Groundwater Application Review Summary Form

Application # G- 18961

PUBLIC INTEREST REVIEW FOR GROUNDWATER APPLICATIONS

A. GENERAL INFORMATION: Applicant's Name: Jane Stockfleth, LLC County: MARION

Theis (1935) Drawdown Analysis

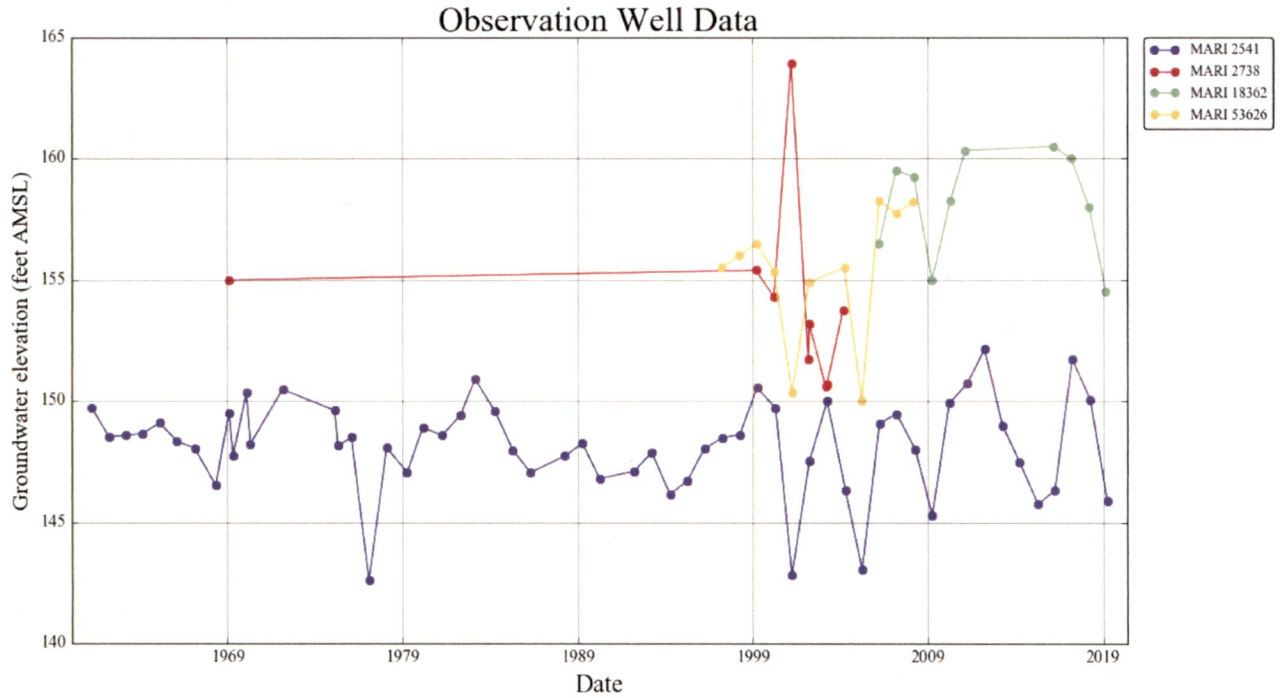
groundwater right exceeds 25 ft, pumping of the proposed wells would need to be curtailed. Results of the analysis indicate that, at the maximum combined rate for POA 3 (6.8931), interference with **MARI 2522** is very likely to exceed 25 ft within ~12 days of continuous pumping. At the requested rate (4.87 cfs), interference with **MARI 2522** is very likely to exceed 25 ft within ~49 days of continuous pumping. At the reported/assumed yields for proposed POA 1-3 (which collectively are not enough to achieve the requested rate), cumulative interference with **MARI 2522** is still likely to exceed 25 ft within ~66 days (see attached Drawdown Analysis). **Therefore, the proposed use will not likely be available in the amounts requested without injury to prior groundwater rights.**

Interference with MARI 2522 at Reported/Assumed Well Yields

Hydrograph

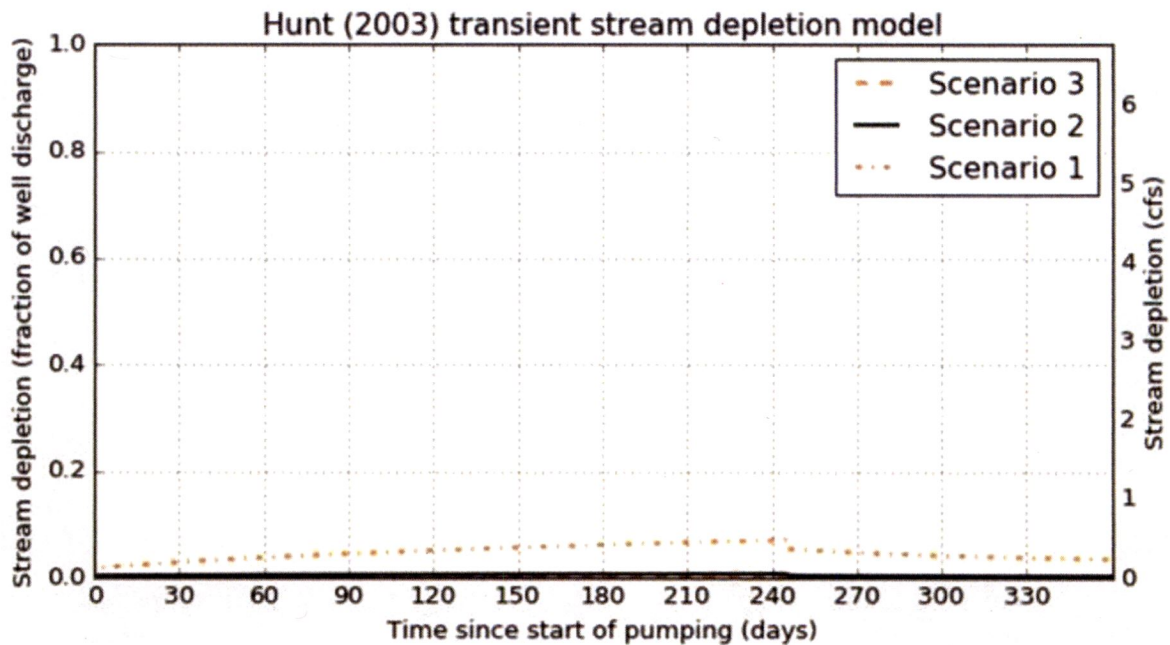
Proposed POA 4 is completed on a high terrace of older deposits from the Missoula Floods and is confined by the fine-grained sediments of the Willamette Silt (Gannett and Caldwell, 1998; O'Connor et al., 2001). Geologic mapping in this area estimates the Willamette Silt as between 80-100 ft thick and the underlying sands and gravels of the Willamette Aquifer as ~40 ft thick (Gannett and Caldwell, 1998). However, the log for **MARI 2540** indicates interbedded fine- and coarse-grained layers to its total depth of ~89 ft below land surface (bls). Nearby water level data does not indicate substantial, persistent declines in the aquifer around proposed POA 4 (see attached Hydrograph).

Stream Depletion Analysis: POA 1 – SW 1

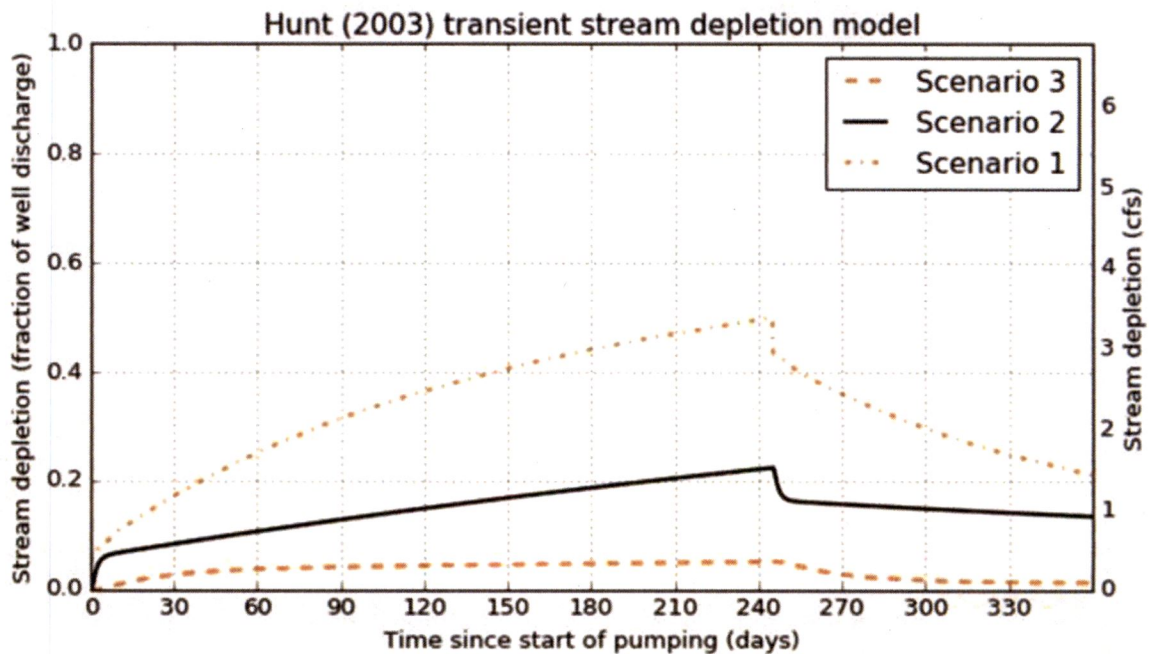
Interference with various surface water sources due to the proposed use was quantitatively estimated using the Hunt (2003) analytical model. Hydraulic parameters used for the analysis were derived from regional data and studies (Pumping Test Reports; Conlon et al., 2003, 2005; Iverson, 2002; McFarland and Morgan, 1996; Woodward et al., 1998) or are within a typical range of values for the given parameter within the hydrogeologic regime (Domenico and Mifflin, 1965; Freeze and Cherry, 1979; Halford and Kuniansky, 2002). Results indicate that none of the proposed POA are anticipated to interfere with (deplete) nearby surface water sources at a rate greater than 25 percent of the rate of withdrawal within the first 30 days of continuous pumping.
